## REVISED RESPONSE TO REQUEST FOR ADDITIONAL INFORMATION

### APR1400 Design Certification

Docket No. 52-046

RAI No.: 264-8243  
SRP Section: 06.02.05 – Combustible Gas Control in Containment  
Application Section:  
Date of RAI Issue: 10/22/2015

**Figure 1 Schematic Diagram for ECSBS Check Valve**

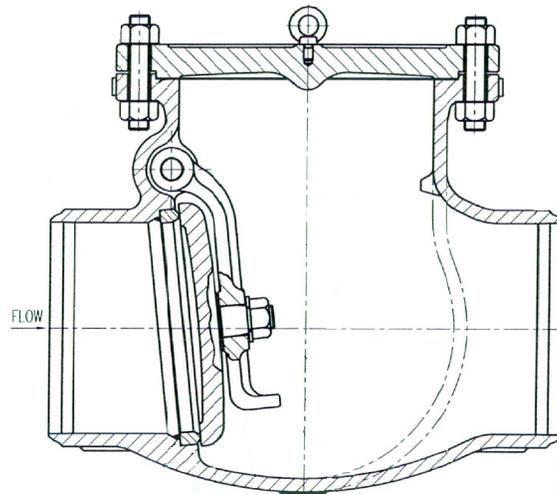
In the equipment survivability analysis described in DCD Tier 2, Section 19.2.3, credit is taken for maintaining the containment pressure below the factored load category of 123 psia, per DCD Tier 2, Section 19.2.4.2.3, by relying on the emergency containment spray backup system (ECSBS). See DCD Tier 2, Figure 19.1-3, Simplified Diagram – Containment Spray System. This is a single train system, with its own dedicated ECSBS spray ring header and an inside containment isolation check valve, V1014. This backup spray function is the basis provided for limiting the equipment survivability analysis to 24 hrs, as stated in DCD Tier 2, Section 19.2.3.3.7.2, "Determination of Severe Accident Environmental Conditions." This valve should

be shown to meet the equipment survivability conditions, including surviving a hydrogen burn and remaining open. This valve should be added to DCD Tier 2, Table 19.2.3-4.

The check valve has another function of water delivery to the ECSBS header during severe accidents. However, the ES evaluation of the check valve is the as same as piping its water delivery function to the ECSBS header, because of the following reasons:

- The check valve resists damage due to temperature increases because it consists of only metallic parts. The metallic parts resist thermal damage according due to the hydrogen burn or continuous temperature rise which results from decay heat.
- It is expected that the check valve continues to function due to its simple structure, as shown in Figure 1.

Therefore, it is not necessary to evaluate the survivability of check valve V1014, [but the valve will be added to Table 19.2.3-4, as shown in Attachment 1 to this response. The discussion of the valve's resistance to thermal degradation will be relocated to a new section within 19.2.3.3.7.4 since the valve is not located outside containment which is the heading of the valve's current discussion.](#)

Figure 19.1-3 Simplified Diagram - Containment Spray System

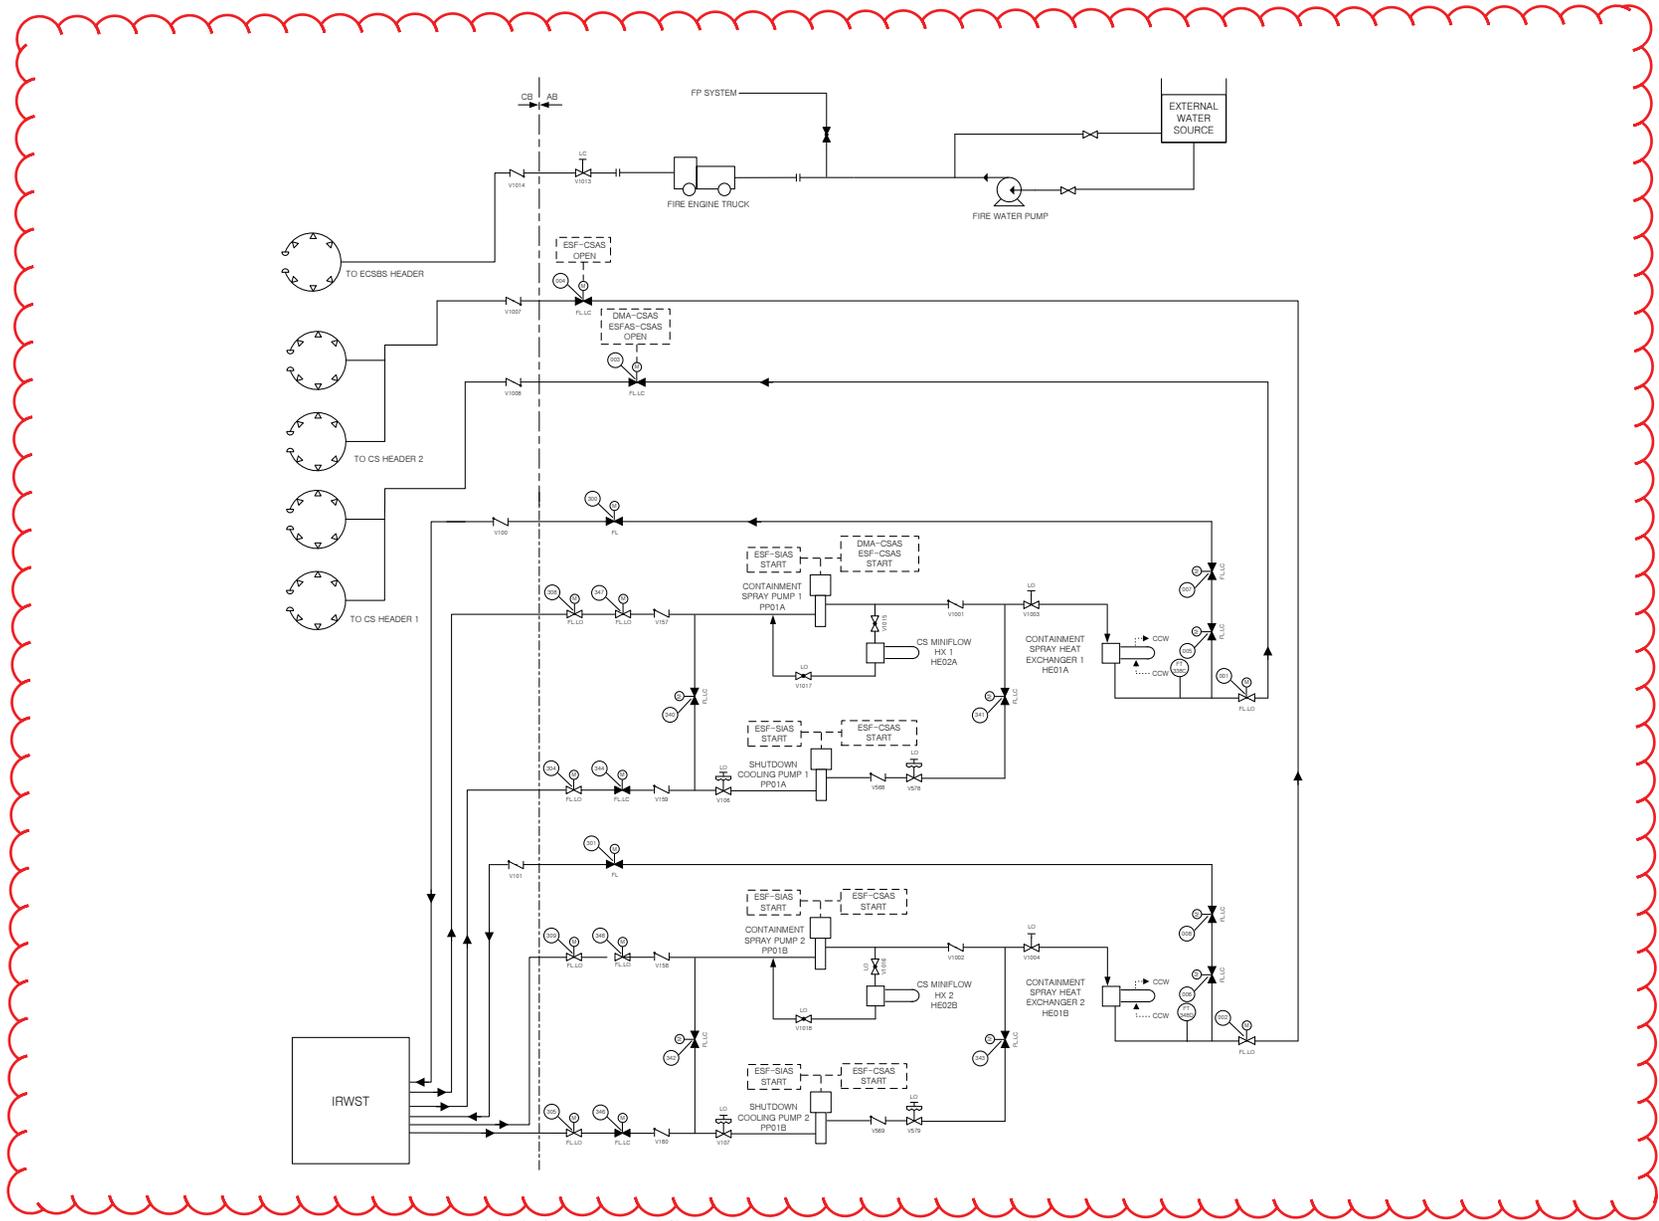
Please confirm that all of the check valves shown in DCD Figure 19.1-3, Simplified Diagram – Containment Spray System, are depicted correctly to indicate the direction of flow. Check valves V1014, V1008, and V1007 appear to be shown in an inconsistent direction as compared to V101 and V100. Adding flow direction arrows below the check valve symbol, as done in DCD Tier 2, Table 6.2.4-1, would provide clarification.

DCD Tier 2, Figure 19.1-3 will be revised to correct the directions of flow for check valves (V100, V101, V1007, V1008 and V1014), as shown in Attachment 2 to this response.
